REQUEST

Approximately 19.52 acres located on the north side of Mallard Creek

The petition proposes to allow the development of a multi-family residential community on acreage partially developed with a single family home and the remainder vacant, and located on the north side of Mallard Creek Road, east of Interstate 485 and west of Concord Mills in Cabarrus County.

Petition 2017-179 (Page 2 of 6) Final Staff Analysis

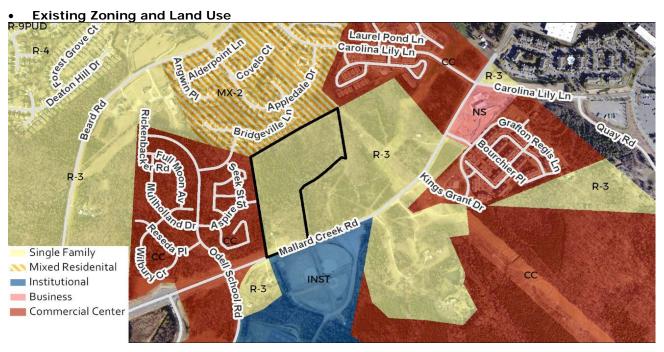
- 1. The petitioner should revise the site plan and conditional note(s) to provide a northbound left turn lane from Mallard Creek to the proposed local private street. The access at Mallard Creek Road may otherwise be restricted to right-in/right-out. Addressed.
- 2. The NCDOT is planning a widening project (U-6032) and may revise the future curbline along the site's Mallard Creek Road frontage during permitting. Addressed.
- No on street parking. Dead end access exceeding 150 feet requires approved Charlotte Fire Department turnaround. See charlottefire.org for other requirements. Petitioner should coordinate with Charlotte Fire to resolve this issue. Petitioner has placed a note on site plan stating dead ends exceeding Fire Department requirement to comply with Fire Department requirements for turnaround, typical.

- 4. Please correct stream buffer labels to specify 50-foot <u>Undisturbed</u> PCSO buffer. Please also add the following note under the ENVIRONMENTAL FEATURES heading: "For adjoining parcels receiving stormwater discharge from proposed BMP(s), the Petitioner shall analyze adequacy of the existing stormwater conveyance on the adjoining parcels. If the existing stormwater conveyance on the adjoining parcels is found to be inadequate, the Petitioner shall make a good faith effort with the property owner(s) to improve the stormwater conveyance or otherwise mitigate the stormwater discharge onto the adjoining parcels." Addressed.

- 5. Please correct stream buffer delineations and labels on the site plans. Within this watershed, all intermittent and perennial streams draining less than 50 acres require a 50-foot undisturbed PCSO buffer (the 35-foot buffer delineations are incorrect).—Addressed.

- Under Development Data Table specify maximum number of stories and building height. Addressed.
- 7. Please shift required Class C buffer out of the 150-foot Duke Energy transmission right-of-way. Addressed.
- 8. Remove drawing on technical data plan sheet. Addressed.
- 9. Revise Note 1.C under General Provisions to clarify that only minor amendments that do not change the intent of the plan will be allowed. Addressed.
